Subject: Arkansas Nuclear One - Unit 2
Docket No. 50-368
License No. NPF-6
Response to First Request for Additional Information from the NRC Reactor
Systems Branch Regarding the ANO-2 Power Uprate License Application

**Request for Additional Information
from Reactor Systems Branch Personnel Regarding the
Arkansas Nuclear One, Unit 2 (ANO-2) Power Uprate License Application**

SAR FIGURE NO. 4.I-1

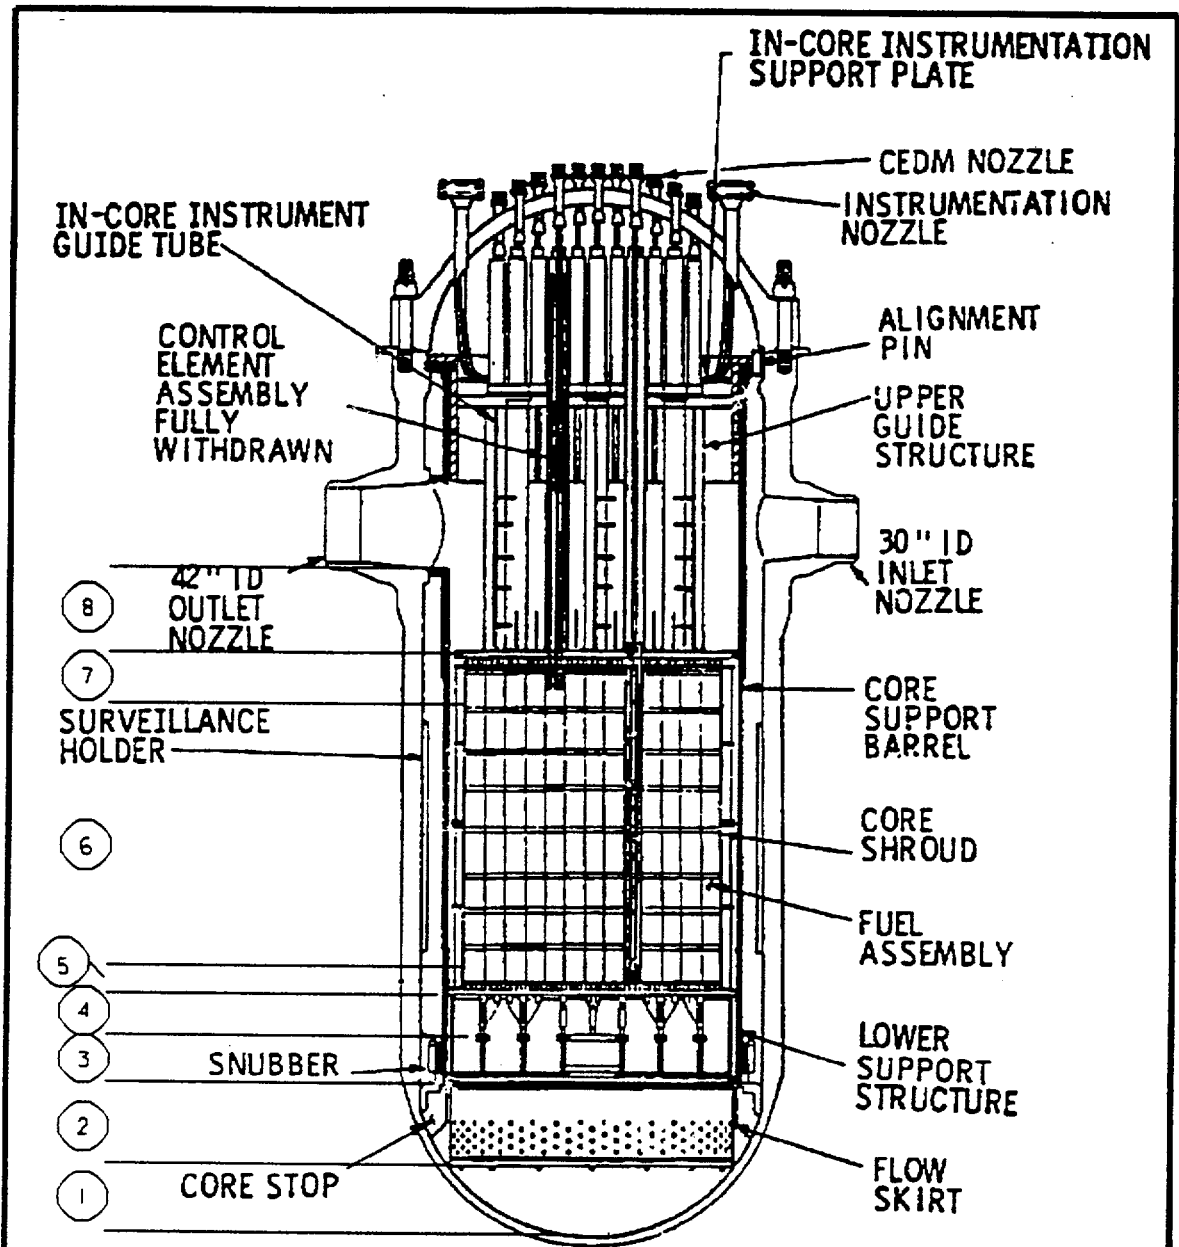
During the September 27, 2001, conference call, the staff requested the value of the mixing volume used in the ANO-2 power uprate boric acid precipitation analysis, as well as various ANO-2 reactor vessel water volumes. A value of 10,532 gallons (1408 ft³) was calculated for the ANO-2 mixing volume. As a discretionary conservatism (i.e., a conservatism not required by the methodology), the input value used in the BORON code was reduced to 10,000 gallons (approximately a 5% reduction). Table 1 lists water volumes for the lower plenum, core, and outlet plenum regions of the ANO-2 reactor vessel. From the information presented in Table 1 on the following page, the total water volume that is inside the core support barrel (excluding the water between the core support barrel and the core shroud) and between the top of the core support structure and the bottom of the core barrel outlet nozzles (i.e., Regions 5 through 8), is 968.1 ft³.

1. See ANO-2 SAR Figure 4.1-1 (next page) that has been annotated with circles drawn around numbers 1-8 to depict the top and bottom elevations of Regions 1 through 8.
